RE: **Variance request**
3620 Woodbine Road
Woodbine, MD 21797

The Health Department received your letter dated December 21, 2007 requesting a variance to waive the Percolation Certification Plan required for the construction of an addition and variance to allow the construction of an addition eight feet from the existing well. The *Howard County Code Subtitle 8, Section 3.805* requires a Perc Certification Plan for the construction of an additional living space to an existing home. The plan is required to designate area available for on site sewage disposal repair in the future. Your letter indicates that perc results are not available for the property. Perc records are available and may be used to develop the perc certification plan. Your request to waive the perc certification plan has been denied and the Howard County Health Department does not offer a variance to allow a well closer than 20 feet to a proposed addition.

PERCOLATION CERTIFICATION PLAN
SITE PLAN / NOTES
SCALE 1"=100'-0"

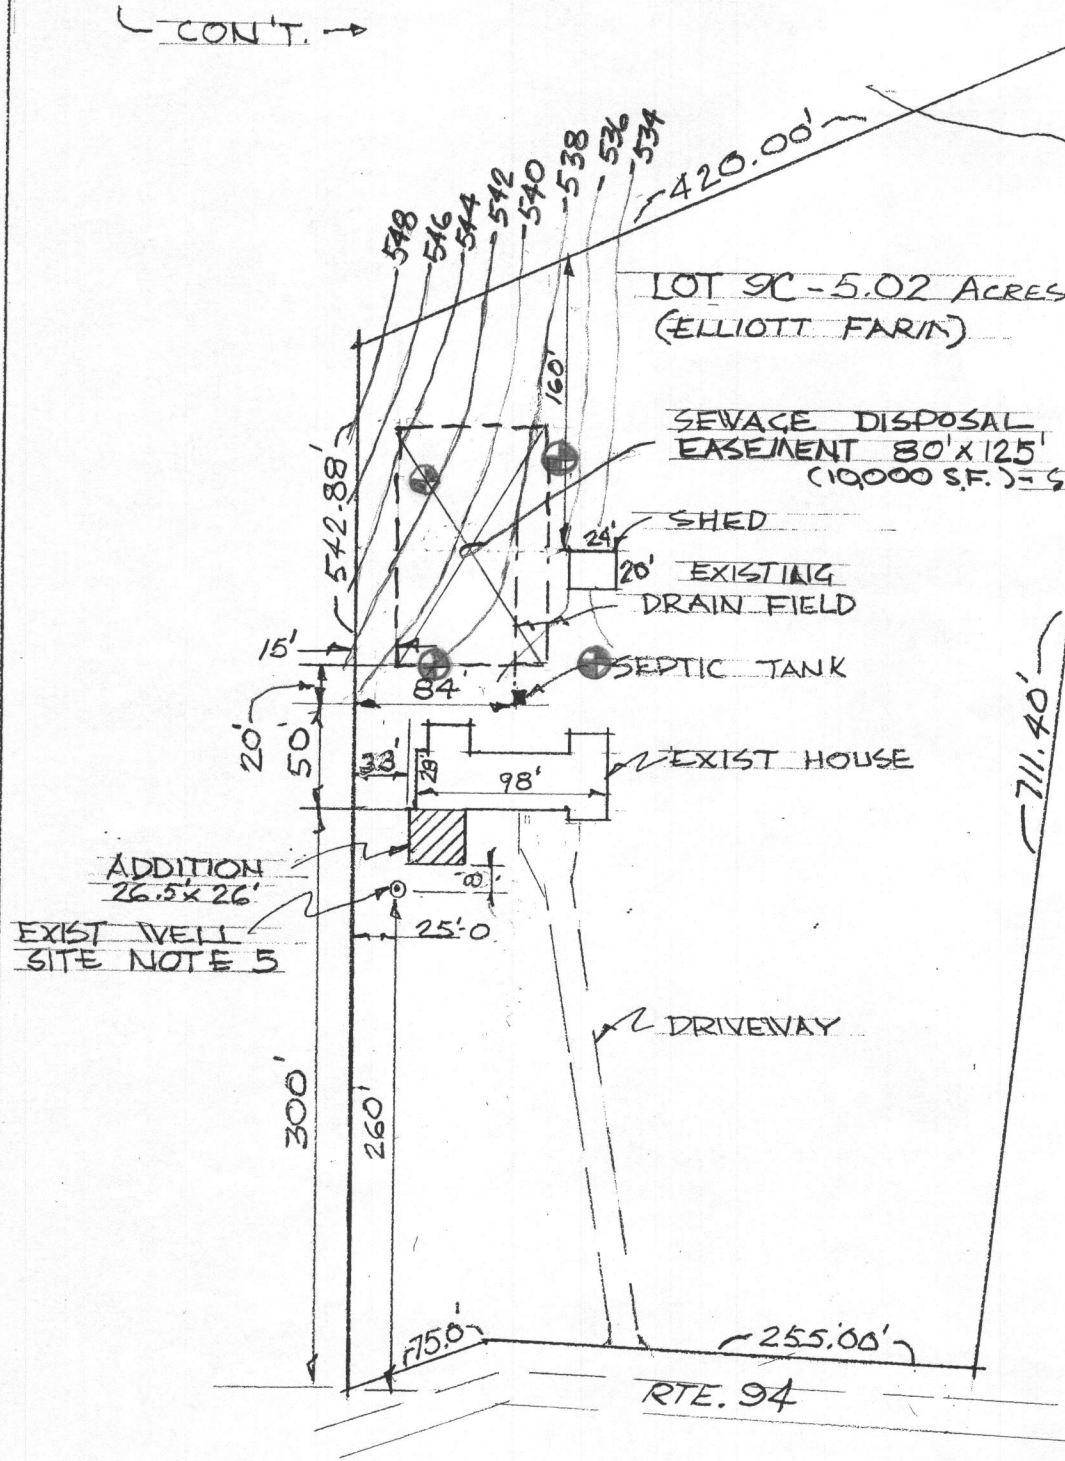
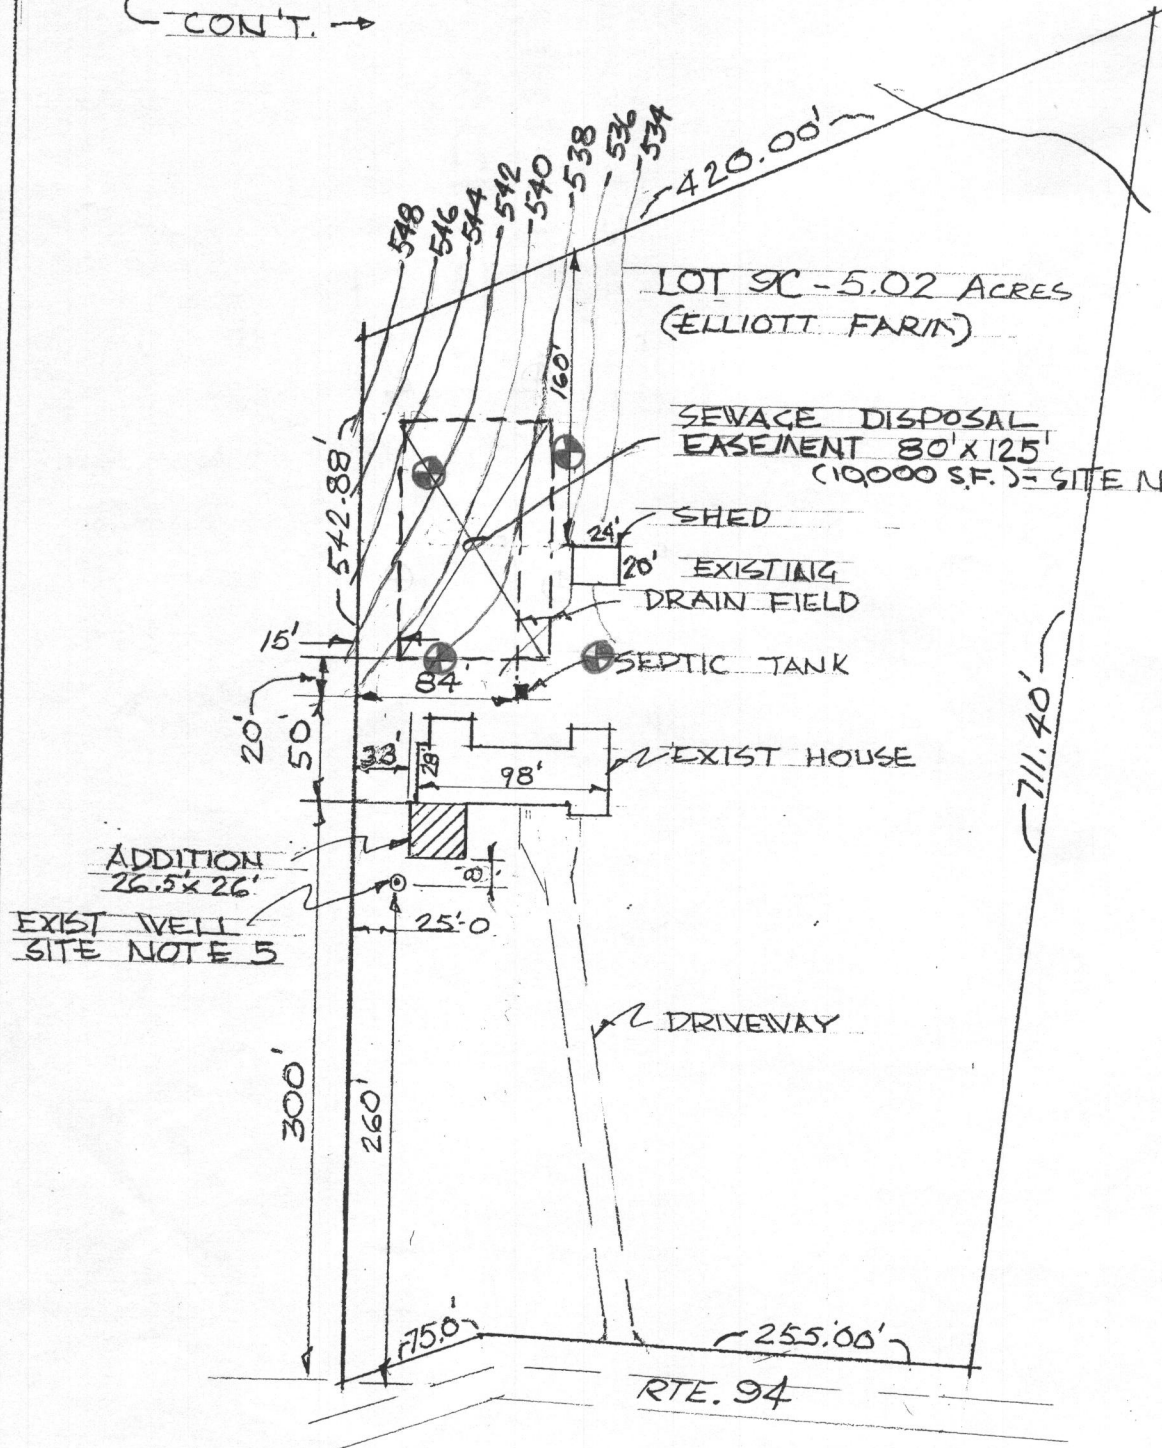
In order to move forward with the project as proposed, a new well must be drilled and a perc certification plan must be developed prior to building permit release.
